1. Conservation Agenda

2. 444 East Central Street

SUBJECT: **Peer Review Comment SW21**
444 East Central Street, Franklin, MA

DATE: **October 16, 2025**

Rating Curve Plot for Crossing: Northern Spy Road

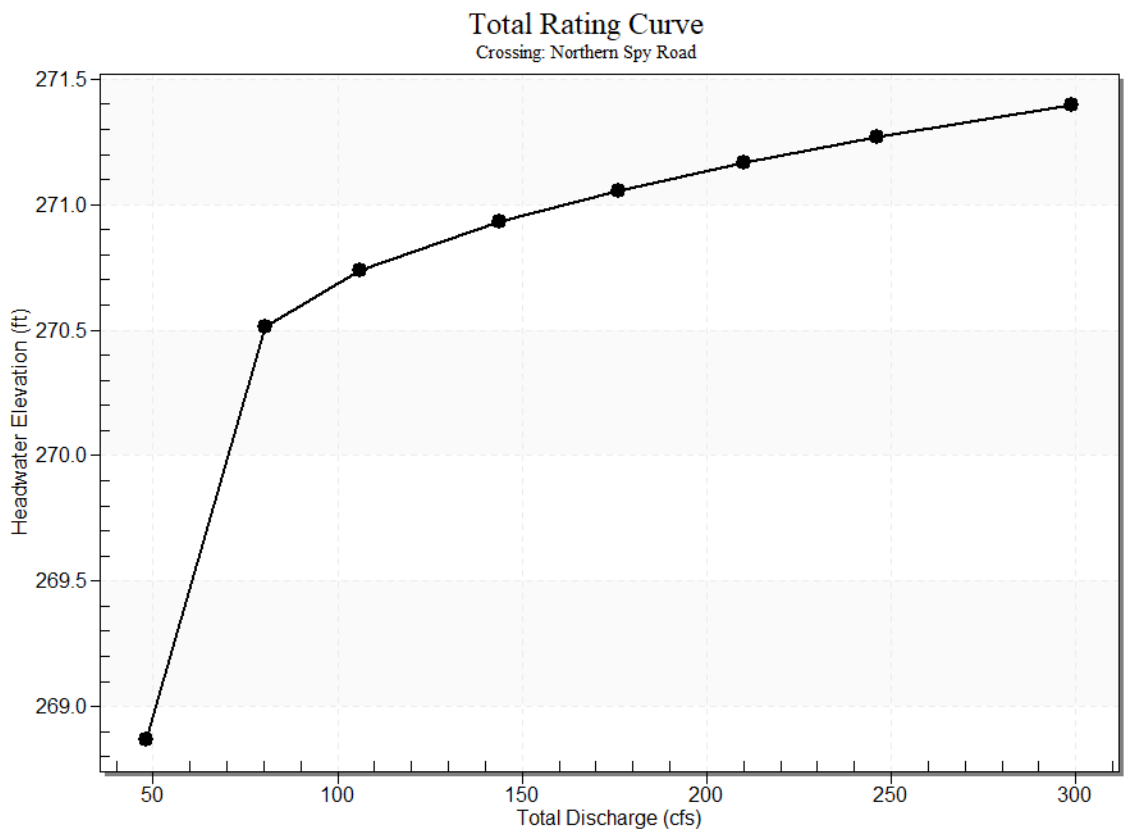
Comment SW21: *The HydroCAD model has been updated, and an HY-8 model has been provided to analyze the capacities for the existing culverts. HY-8 should also be used to model the proposed conditions to demonstrate there will be no adverse impacts to flood levels following construction.*

The Northern Spy Road culverts were not altered in the updated model. The original results from the analysis at that point remain for this updated analysis. As was previously noted, the results at Northern Spy Road indicate that the roadway overtops between the 2- and 5-year events with the water level continuing to rise throughout the various storms.

Northern Spy Road Analysis		
Storm Event (year)	Total Discharge (cfs)	Headwater Elevation (ft)
2	48	268.87
5	80.3	270.51
10	106	270.74
25	144	270.93
50	176	271.06
100	210	271.17
200	246	271.27
500	299	271.40
